UFP SITE BUILT

SMITH DOUGLAS - NASHVILL

TRUSS: A7
JOB ID: 72332272
DELIVERY DATE: 11/15/2023

REPAIR ID: MII-REP01A1 (ATTACHED)

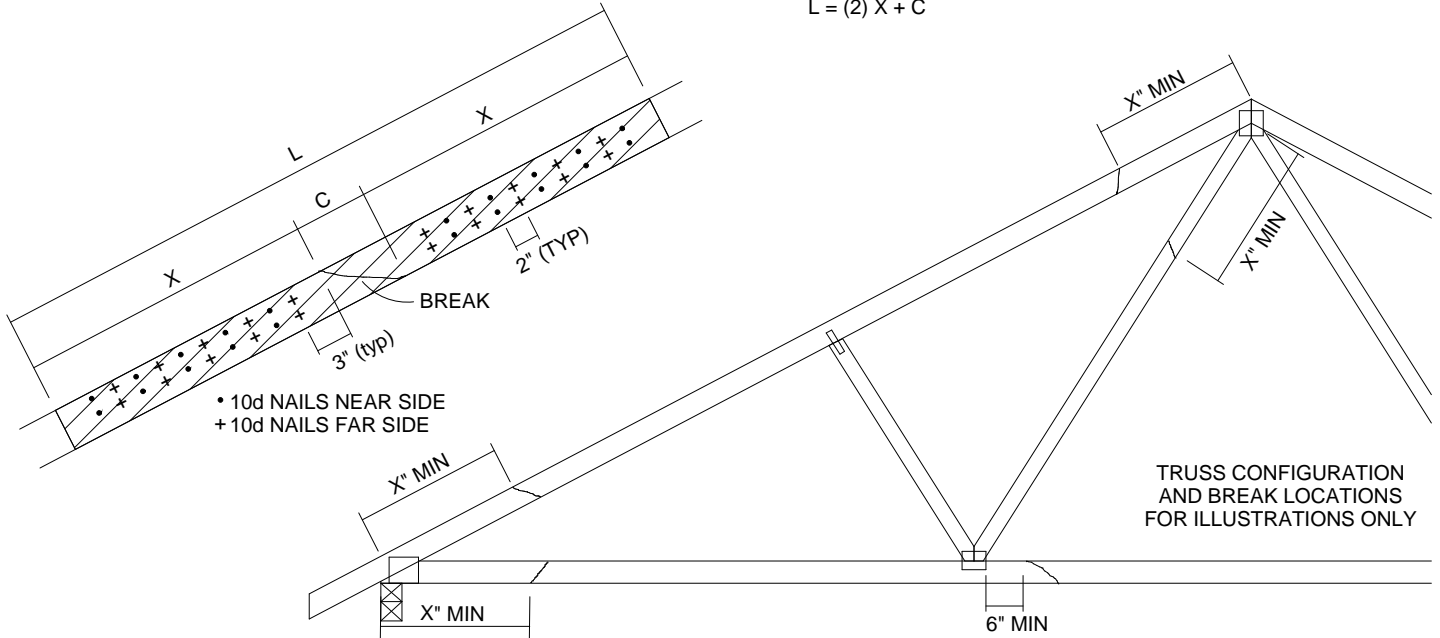
REQUESTED BY: Wells, Reagan
EMAIL: rwells@smithdouglas.com
REQUESTED ON: 12/11/2023

ATTACH 2x_ SCAB OF THE SAME SIZE AND GRADE AS THE BROKEN MEMBER TO EACH FACE OF THE TRUSS (CENTER ON BREAK OR SPLICE) WITH 10d (0.131" X 3") NAILS (TWO ROWS FOR 2x4, THREE ROWS FOR 2x6) SPACED 4" O.C. AS SHOWN. STAGGER NAIL SPACING FROM FRONT FACE AND BACK FACE FOR A NET 0-2-0 O.C. SPACING IN THE MAIN MEMBER. USE A MIN. 0-3-0 MEMBER END DISTANCE.

THE LENGTH OF THE BREAK (C) SHALL NOT EXCEED 12". (C=PLATE LENGTH FOR SPLICE REPAIRS)
 THE MINIMUM OVERALL SCAB LENGTH REQUIRED (L) IS CALCULATED AS FOLLOWS:
 $L = (2) X + C$

THE LOCATION OF THE BREAK MUST BE GREATER THAN OR EQUAL TO THE REQUIRED X DIMENSION FROM ANY PERIMETER BREAK OR HEEL JOINT AND A MINIMUM OF 6" FROM ANY INTERIOR JOINT (SEE SKETCH ABOVE)

DO NOT USE REPAIR FOR JOINT SPLICES
